**Planning & Zoning Commission
Tuesday, June 20, 2023, 6:00 PM
Public Meeting Room / Eagle Town Hall
200 Broadway, Eagle, CO 81631**

1. Project: Alpine Lumber Shed Minor Development Permit
File # DR23-02
Applicant: Rob Scott of Alpine Lumber
Location 111 Chambers Avenue
Staff Contact: Peyton Heitzman, Planner II
Request: A Minor Development Permit with design variances to construct a shed adjacent to Eby Creek Road.

REQUEST: A Minor Development Permit with design variances to construct a shed adjacent to Eby Creek Road.

100 SITE LAYOT PLAN - PROPOSED
C200 SCALE: 1" = 20'-0"

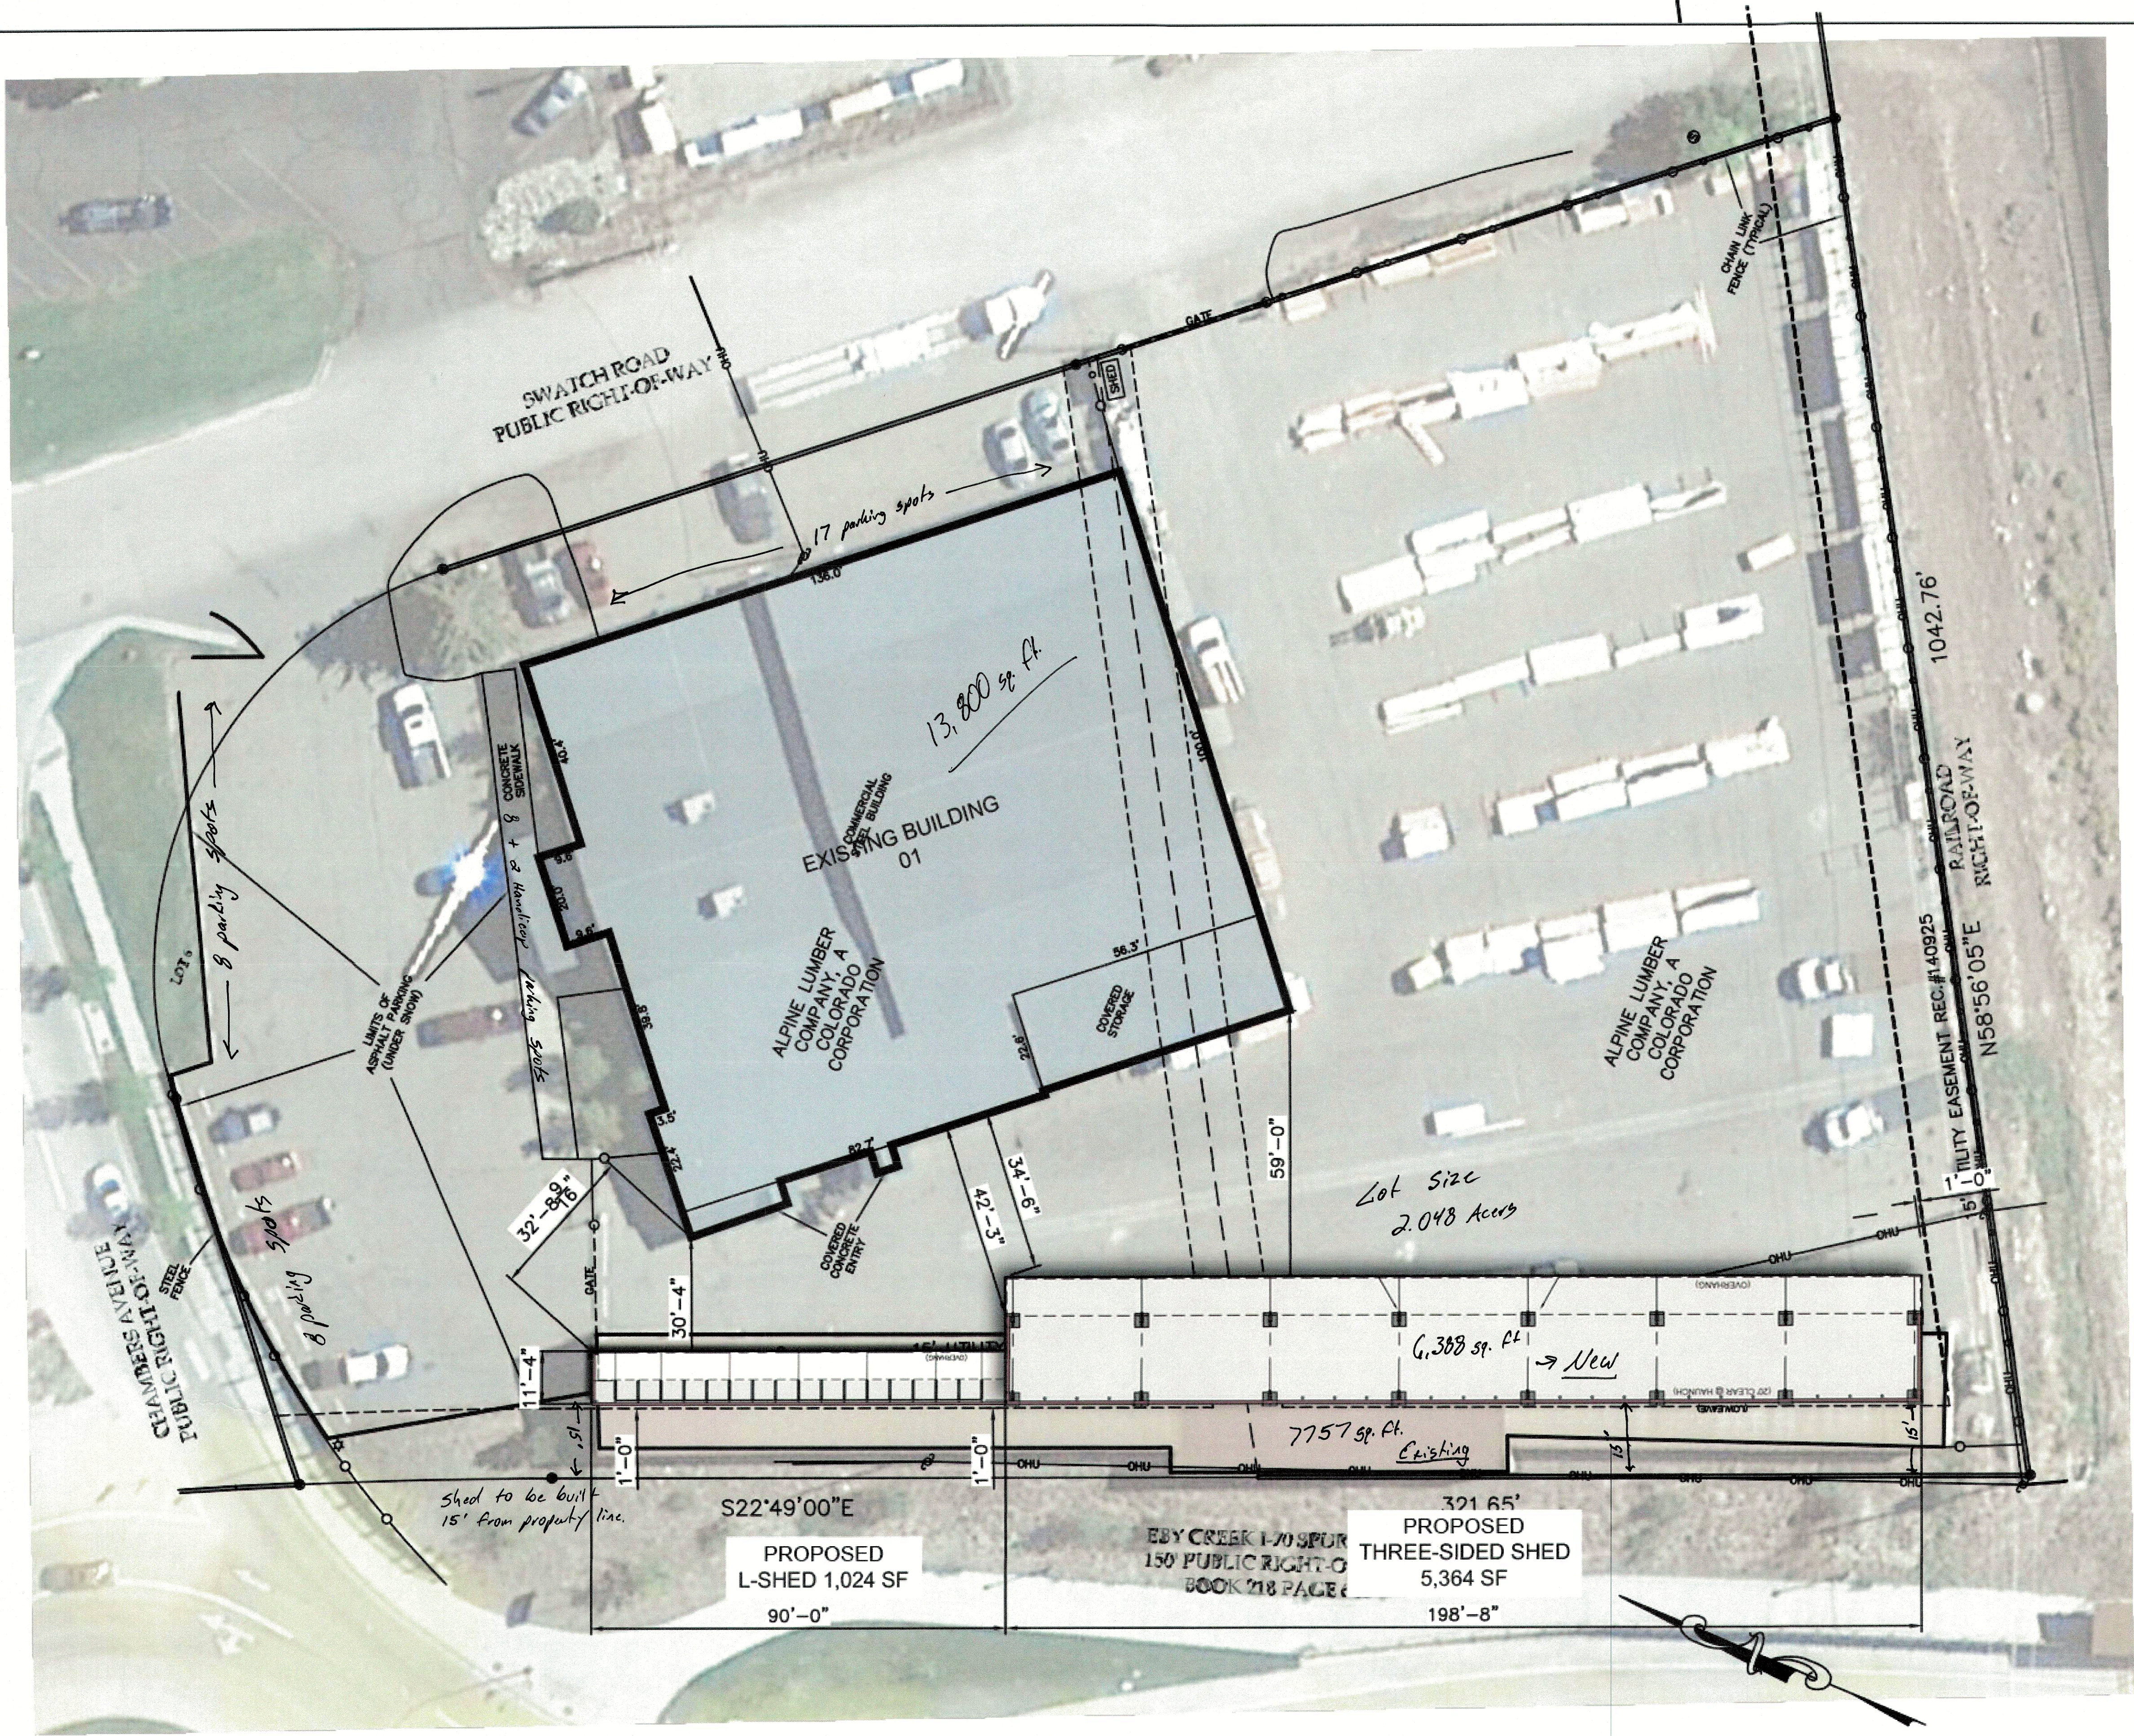
Staff Comment: There are 17 parking spaces on the east side of the primary building that are accessed off Sawatch Road, a local street, and may not be fully accessible in forward drive as shown in the images below. There is a design variance associated with this standard.

Staff Comment: There are 17 parking spaces along the eastern side of the property and 16 parking spaces to the north side of the property without a parking island to separate the spaces. The Applicant is requesting a design variance from this standard.

Staff Comment: The portion of the parking lot that is adjacent to Chambers Avenue is partially screened by transparent black fencing. There are also trees in the right-of-way that provide screening from the road. The parking along Sawatch Road does not provide screening other than a landscaped peninsula at the corner of the building. The Applicant is requesting a design variance from this standard.

Staff Comment: Of the 43 parking spaces provided, 26 spaces are located between the property line abutting the public right-of-way and the primary building. The Applicant is requesting a design variance from this standard.

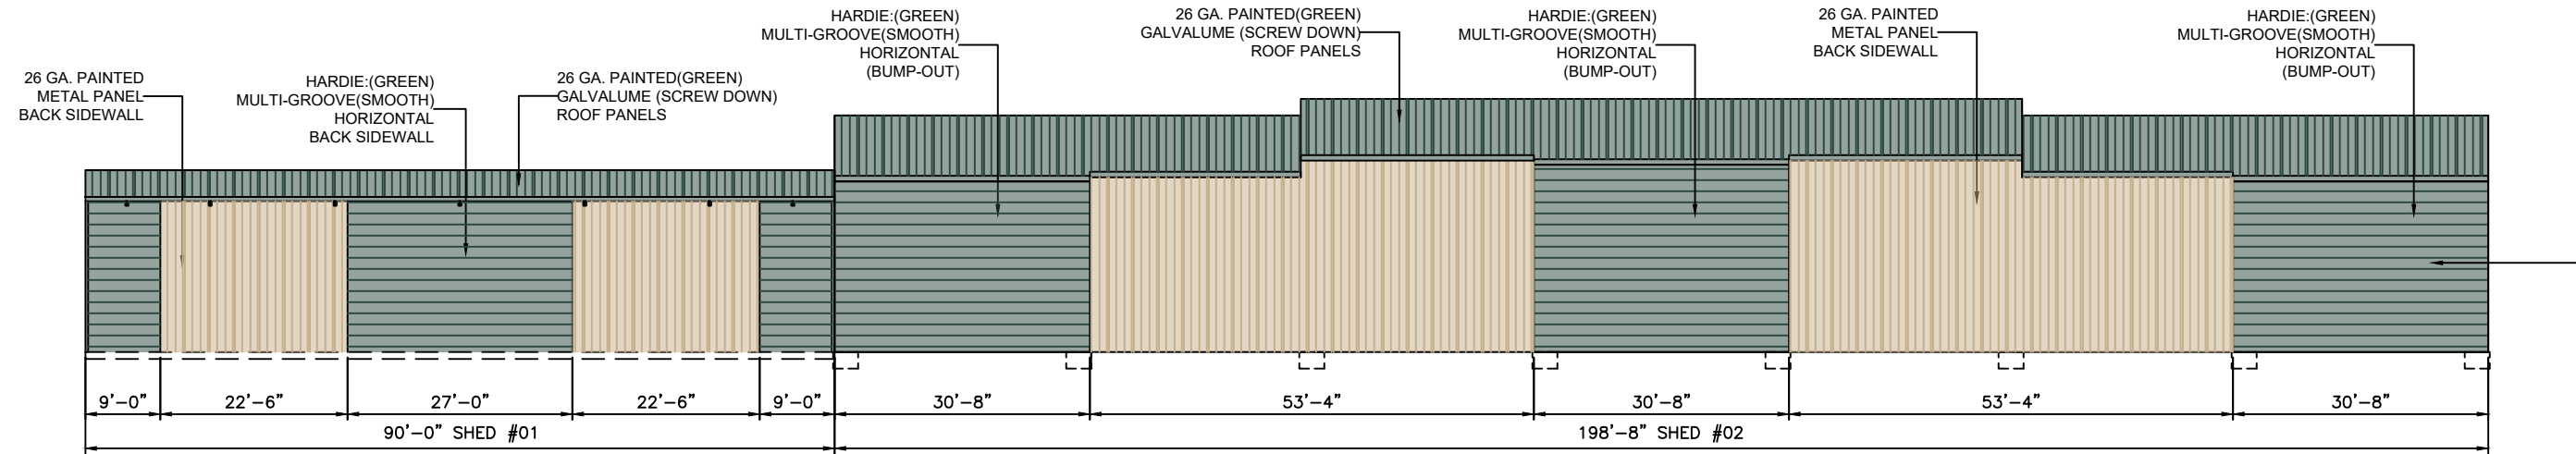
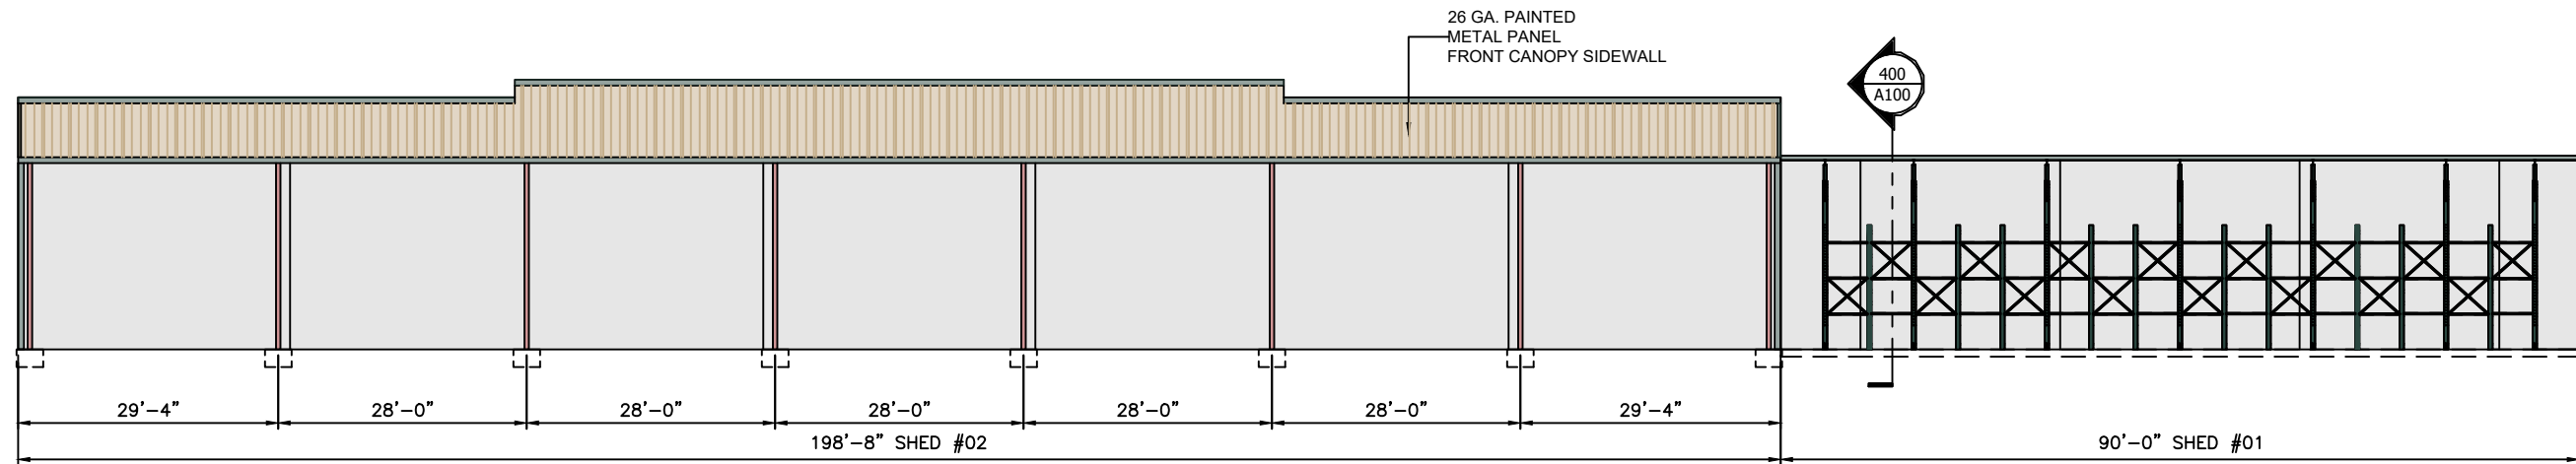
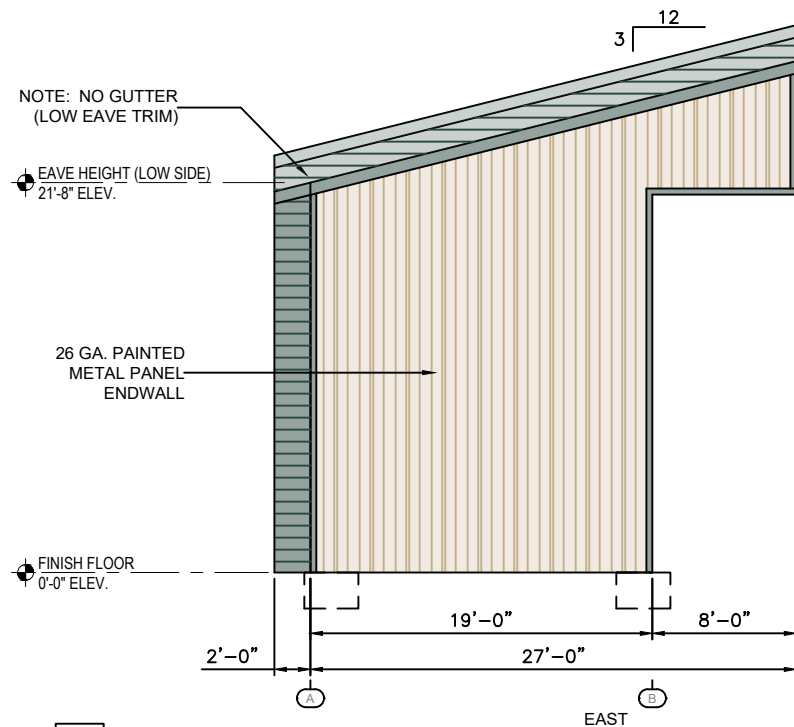
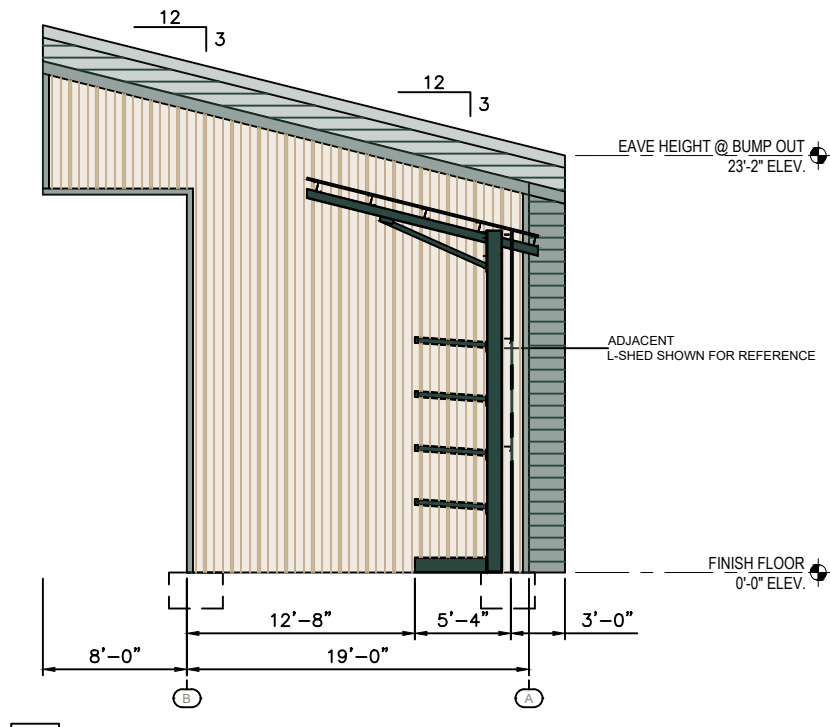
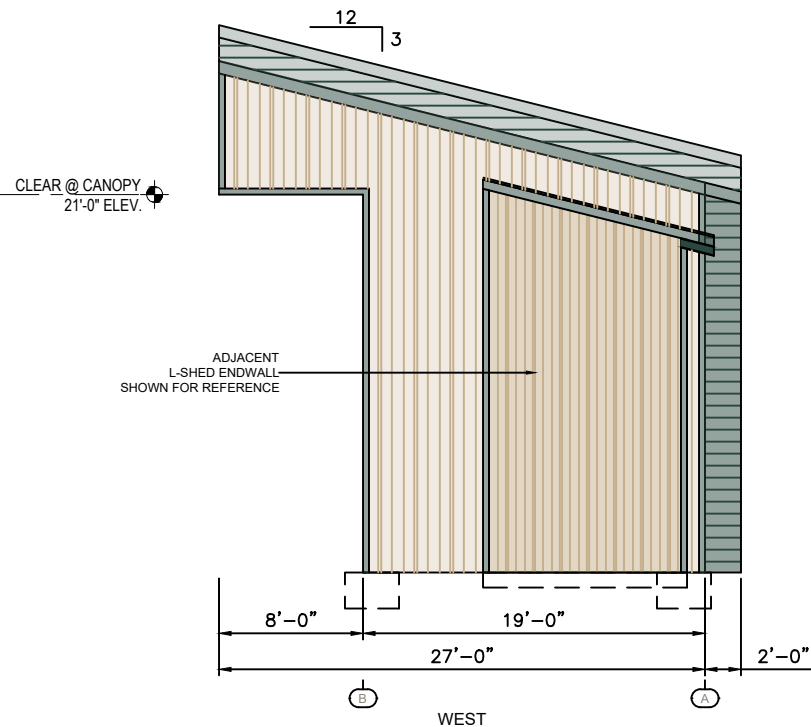
Staff Comment: The applicant has utilized several design techniques to provide variety and visual interest including varying roof heights, a mix of colors and materials, building projections and recessions, and the use of vertical and horizontal siding. The proposed shed is of a simple, rectangular form with a shed roof, following the building styles traditionally used within the Town. Porches and windows are not included with the architectural design.

Staff Comment: The proposed design includes a variation of wall planes with projections and recessions of more than 20% of the length of the façade. The Applicant is requesting a design variance from the depth of the projections/recesses which are required to be at least 3% the length of the façade. The analysis for this design variance is provided later in the staff report. There is no superficially applied trim, graphics, or paint.

Staff Comment: The size of the new shed is 6,388 square feet. The proposal shows a shed roof with varying roof lines to add visual interest to the overall design. While the code requires a minimum roof pitch of 5:12, the Applicant is requesting a design variance for a roof pitch of 3:12 for consistency with the primary building on the lot.

Staff Comment: Staff finds the proposed light yellow and green colors to be neutral and earth tone, meeting the color standards in the Code. The proposal employs two materials, one is vertical metal panel siding and the other is horizontal Hardie, however, the Applicant is considering using a wood composite (shown in the image to the right) instead of the Hardie material. The roof is made of panel sheet metal. Staff is working with the Applicant on modifying the roof design to include a matte finish. There will be an update on this standard at the Tuesday meeting.
